VEPCO NOMAD CODE AND MODEL SUPPLEMENTAL INFORMATION.

Docket # 50-280
Control # 8407170305
Date 7/6/84 of Document:
REGULATORY DOCKET FILE

RESPONSE TO QUESTIONS AND COMMENTS ON VEPCO NOMAD CODE AND MODEL (VEP-NFE-1)

FIGURE 9.7

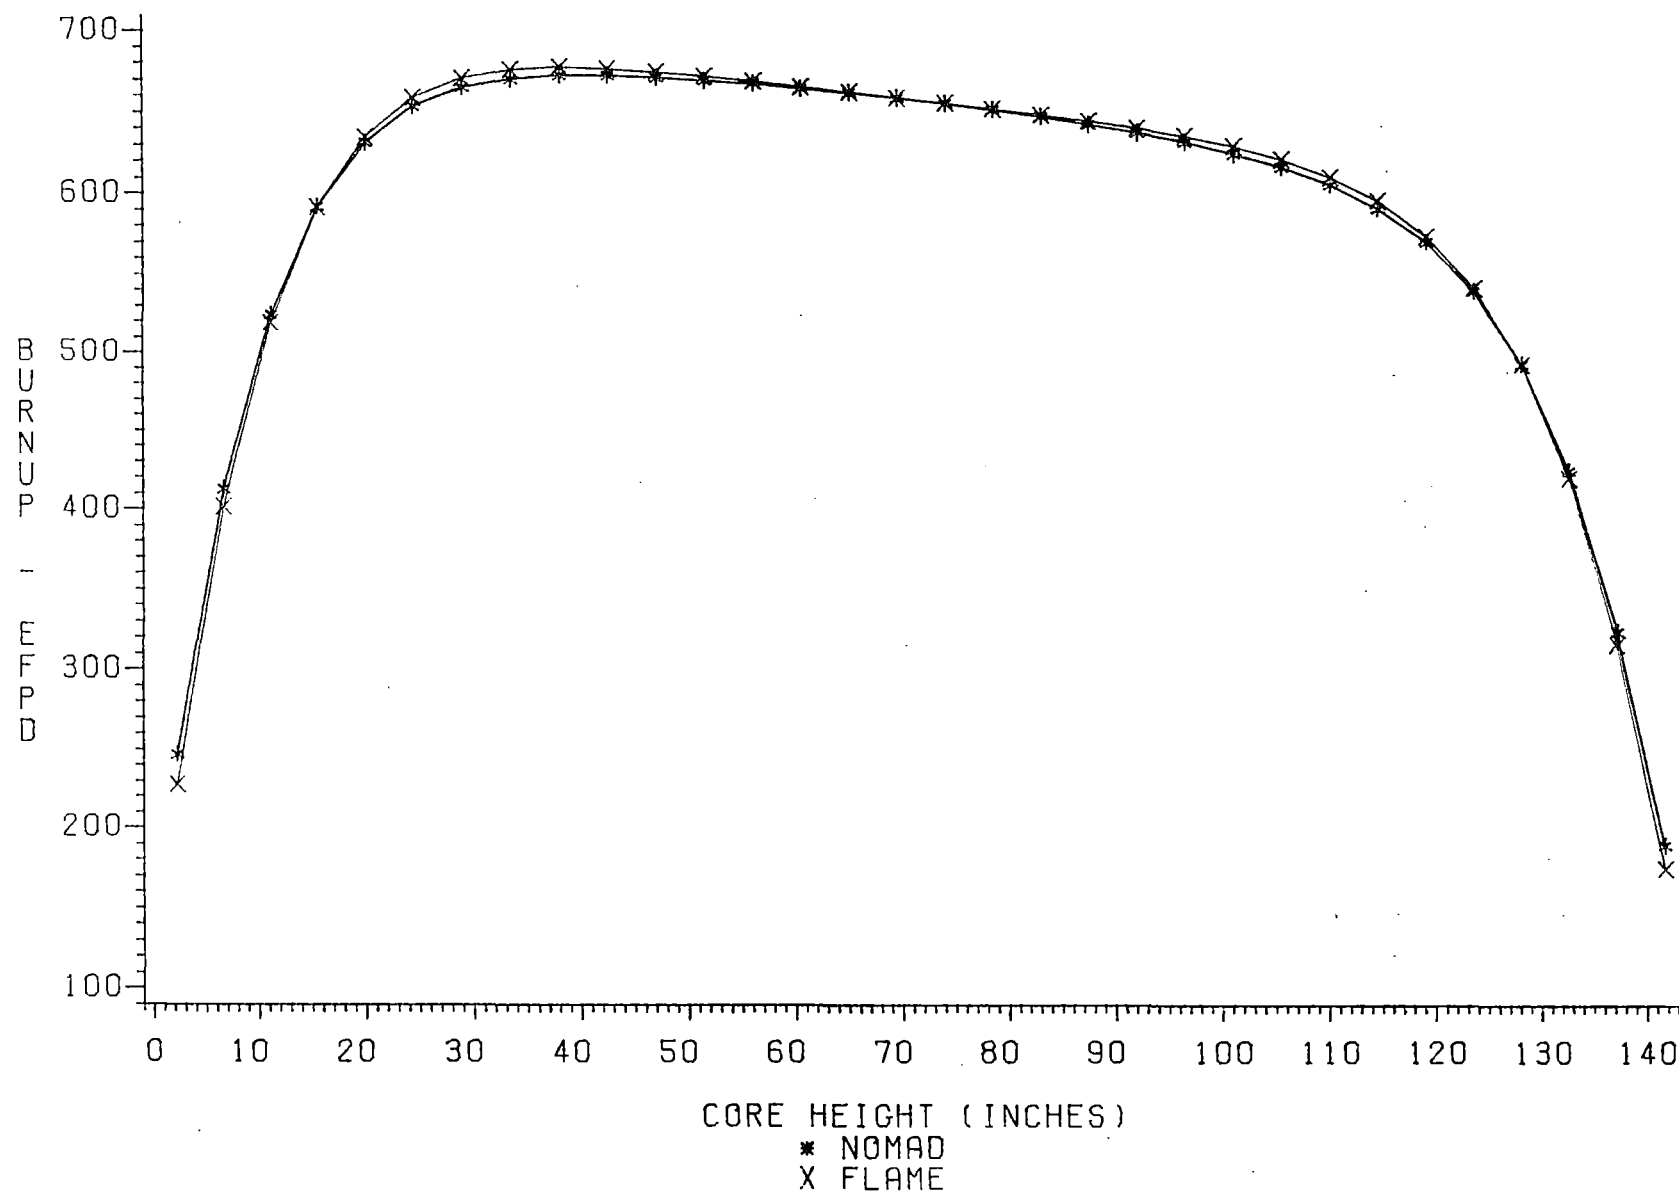
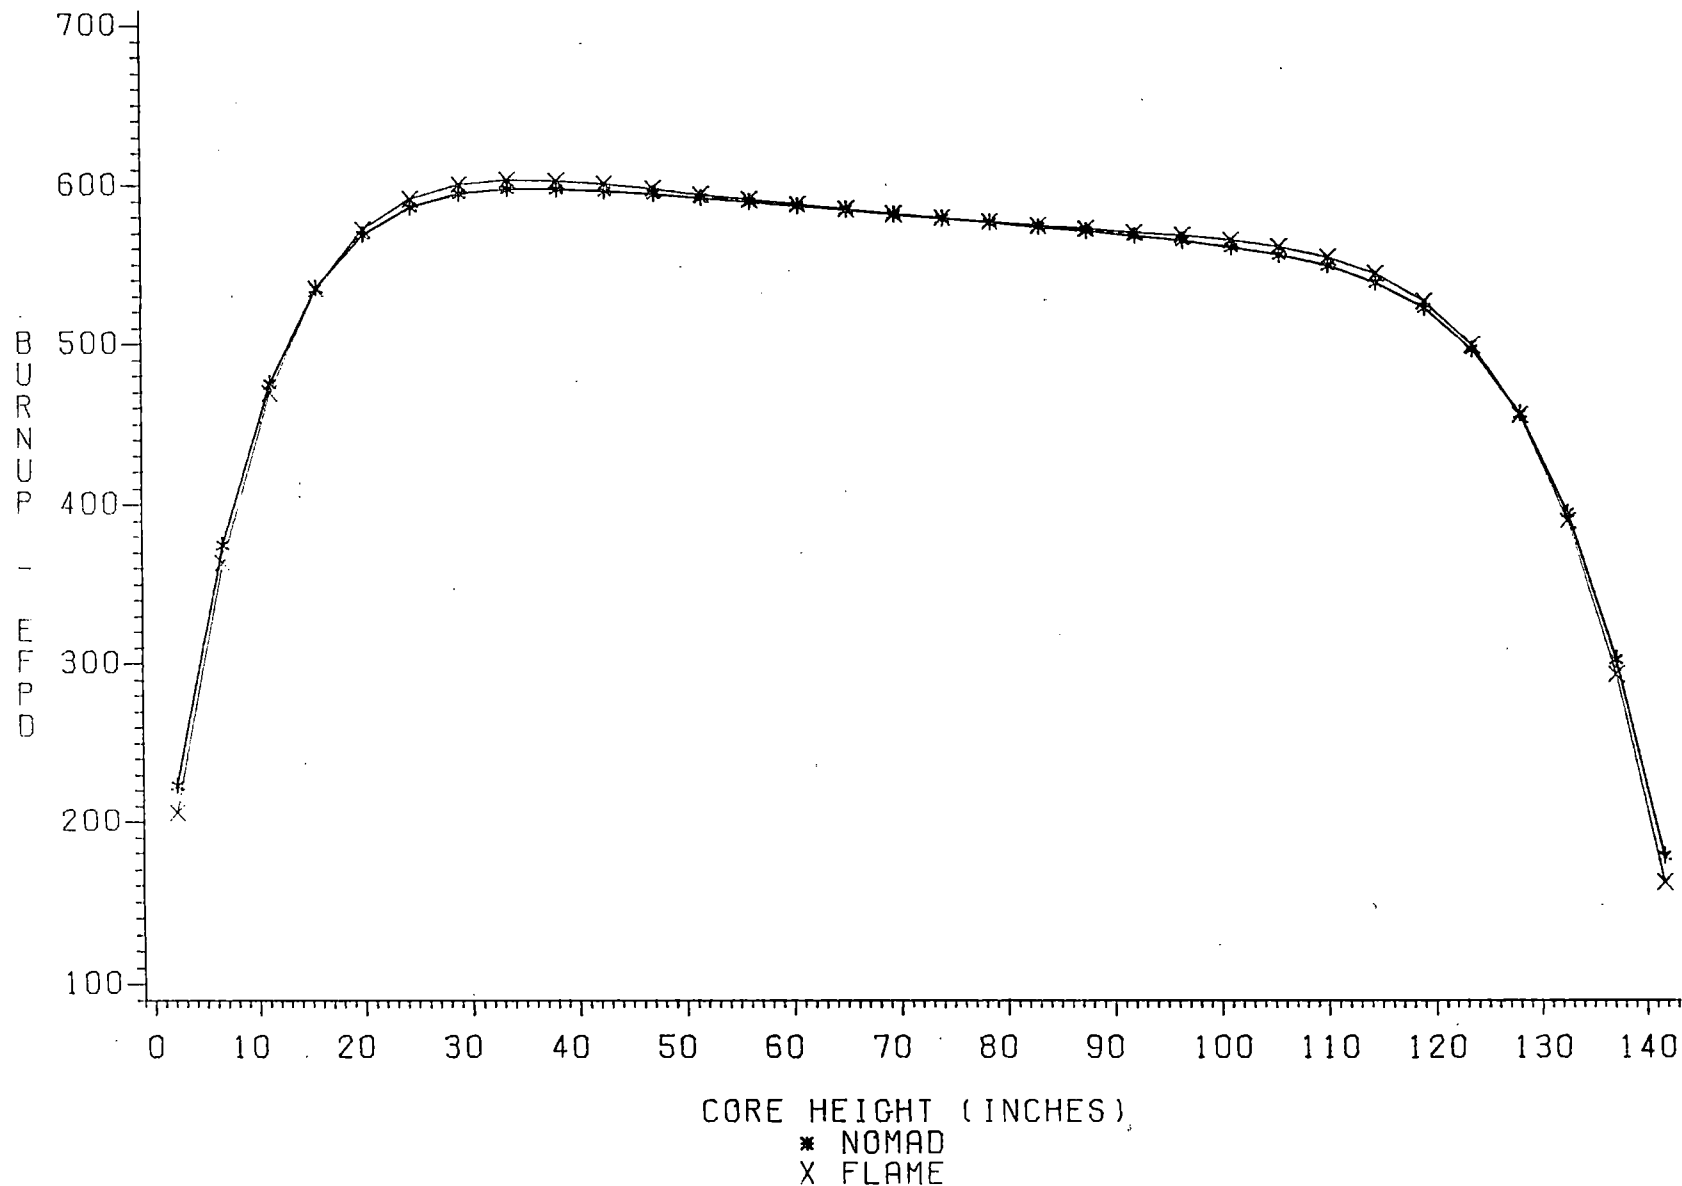
Question 9. Since the NOMAD model incorporates a depletion calculation, comparisons of predicted and measured axial power distributions as a function of burnup should be presented to validate the depletion model. For example, how do EOC axial power distributions compare with measurement?

Figures 9.7 and 9.8 compare EOC axial burnup distributions obtained with NOMAD and FLAME for two cycles. These figures confirm that the NOMAD depletion methodology is consistent with that of FLAME.

FIGURE 10.1

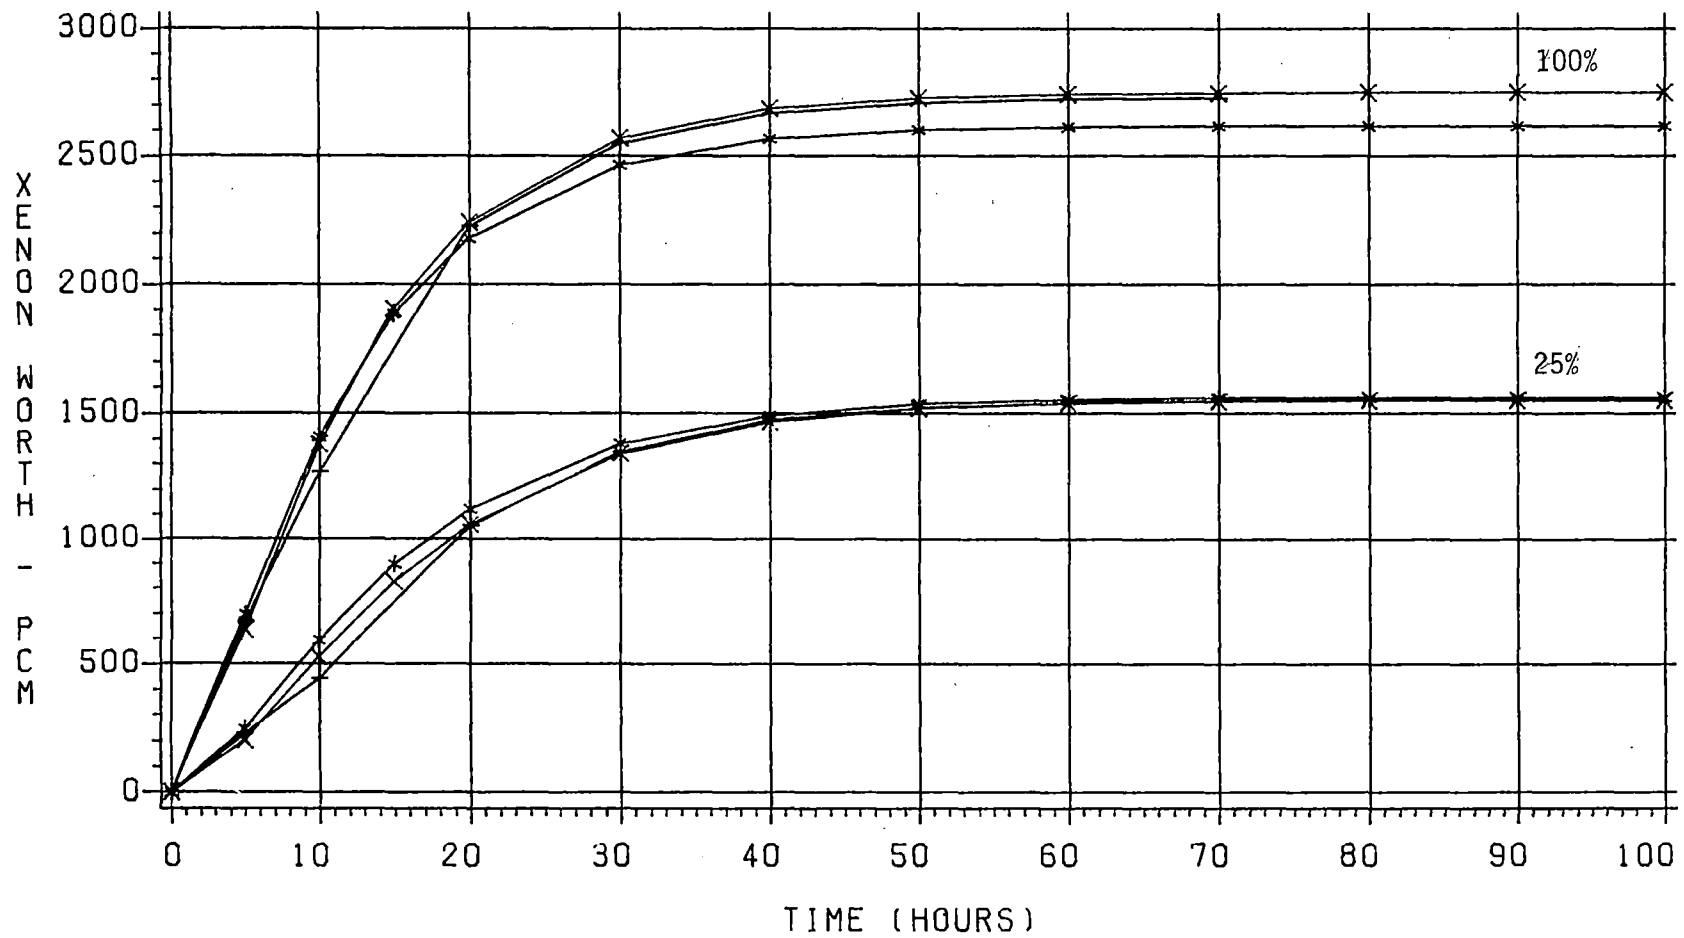
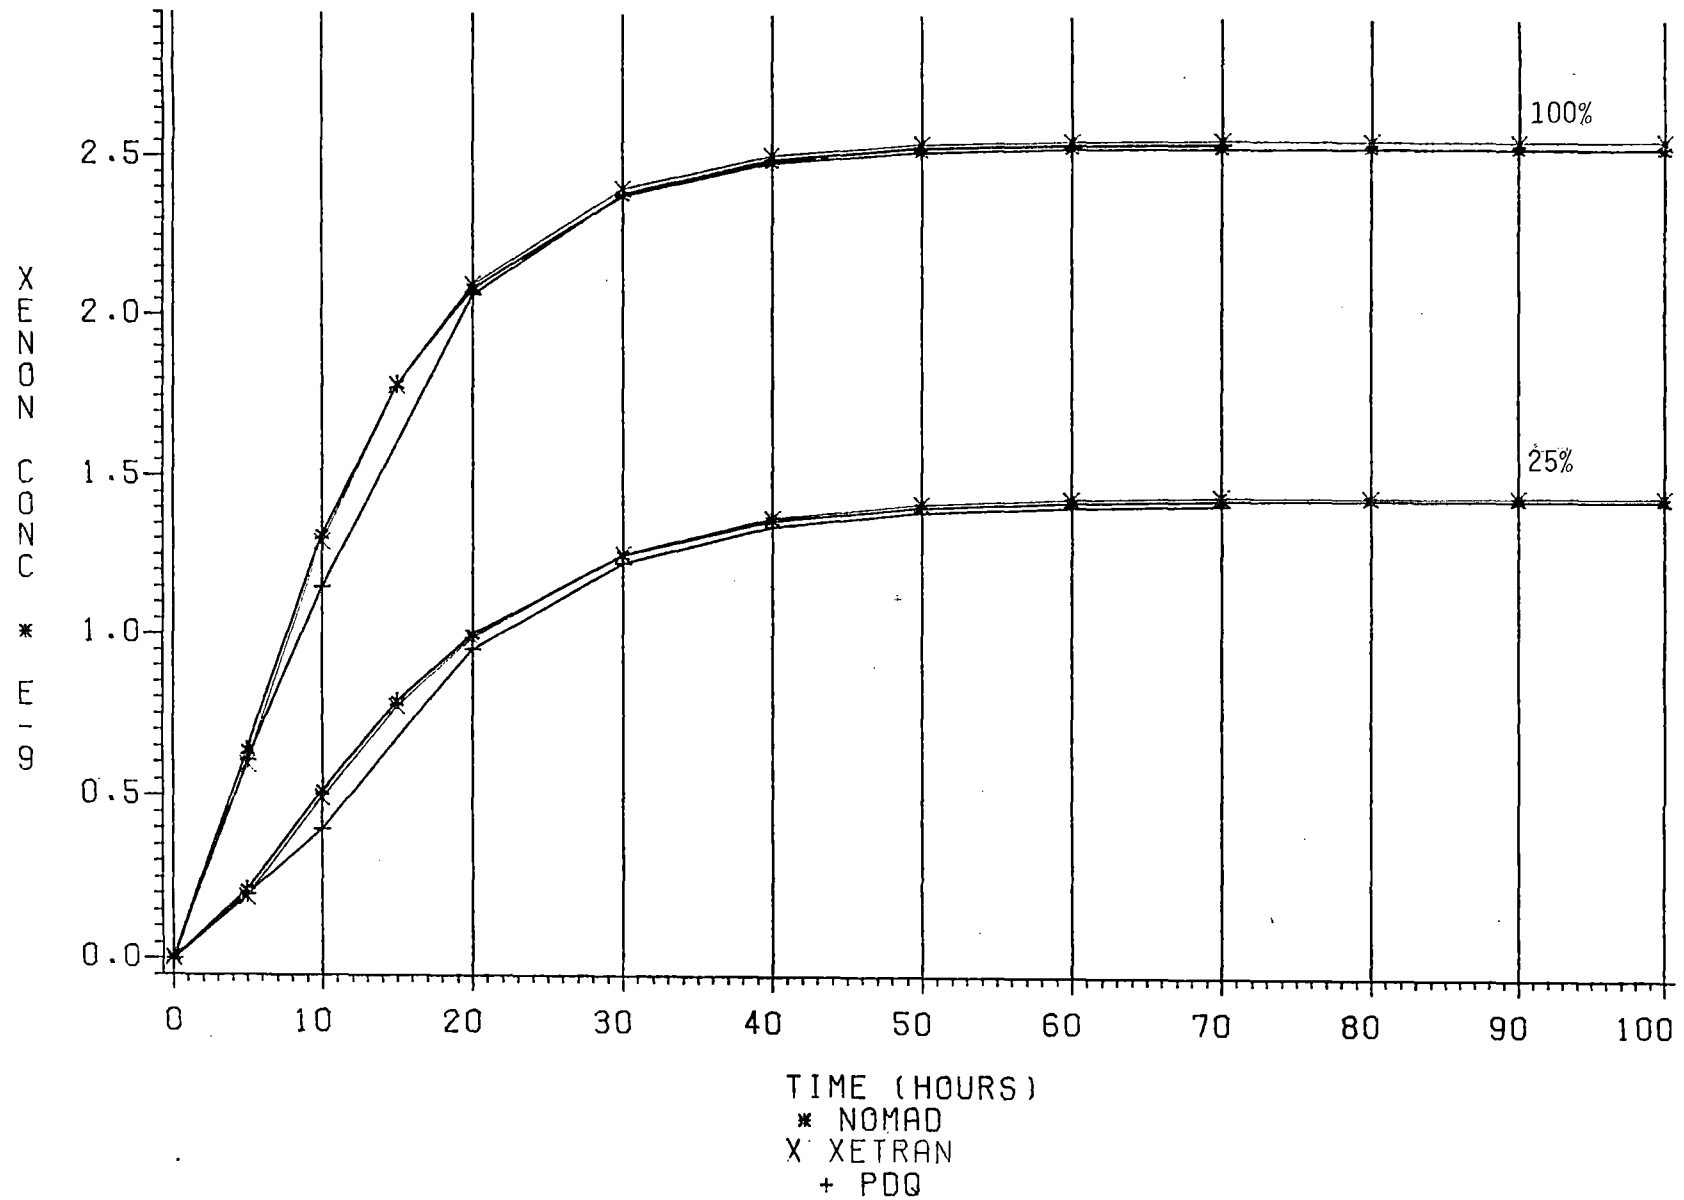
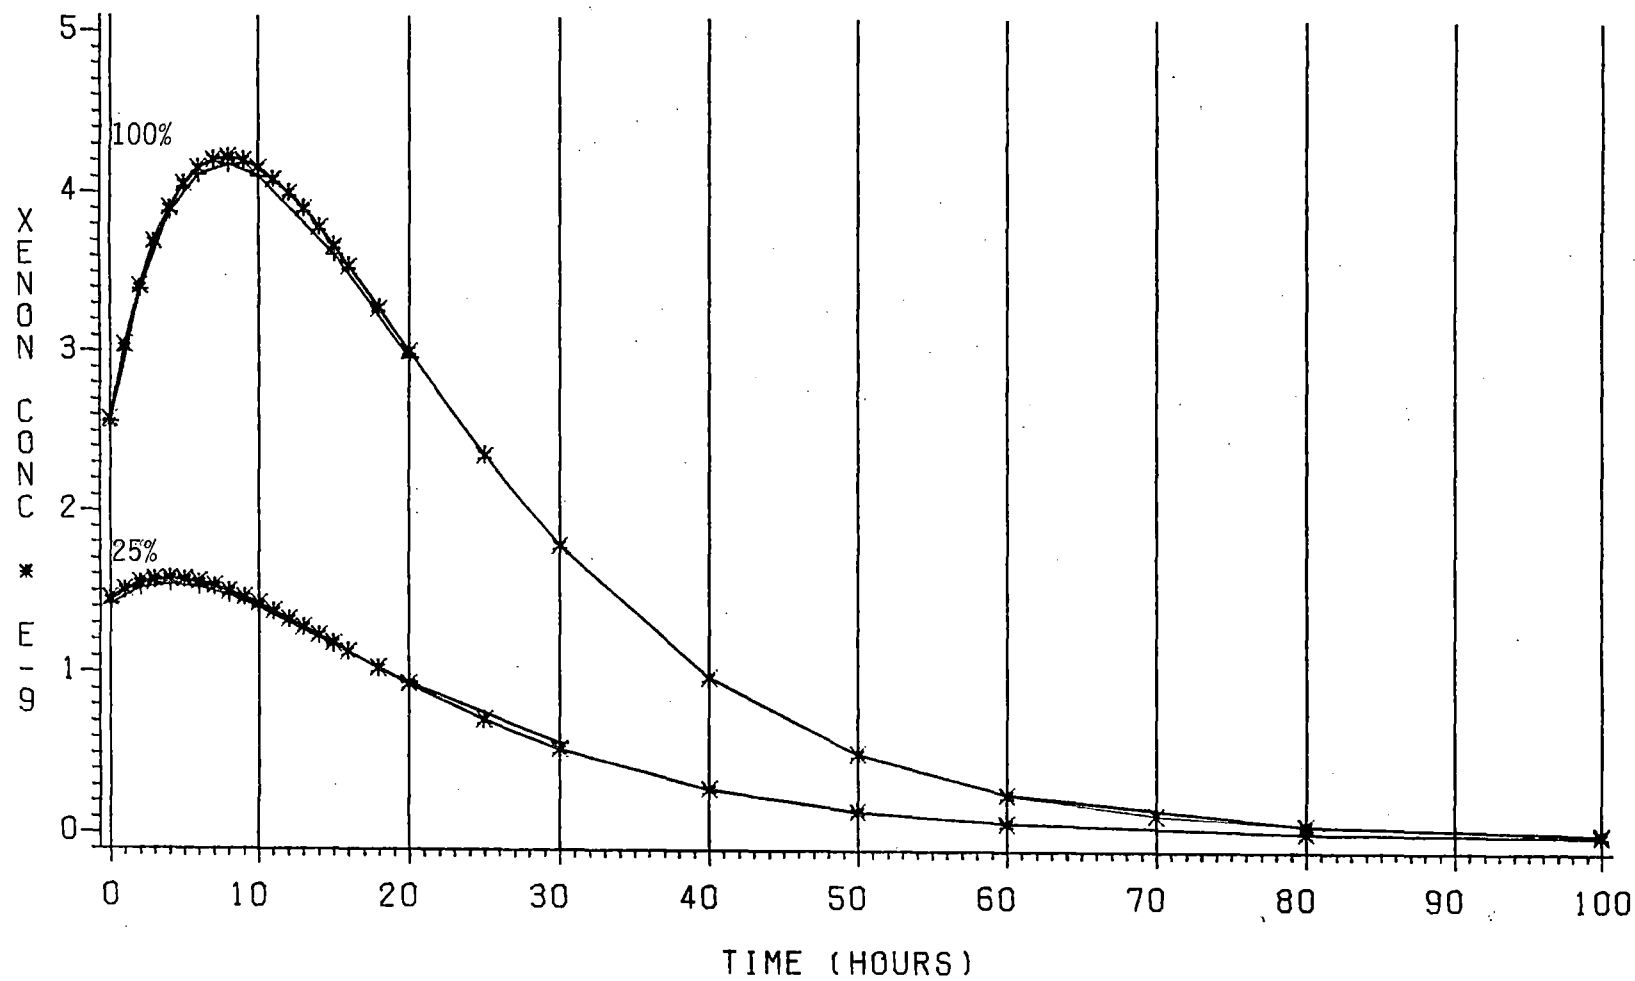
Question 10. NOMAD calculated xenon worths are compared to results obtained from the XETRN code. Since XETRN is a point kinetics code and also has not been reviewed and approved by the NRC, justify its use a reference calculation.

Xenon worth results from NOMAD, XETRAN, and PDQ are compared in Figures 10.1 and 10.2. Xenon concentrations for the same cases are shown in Figures 10.3 and 10.4.
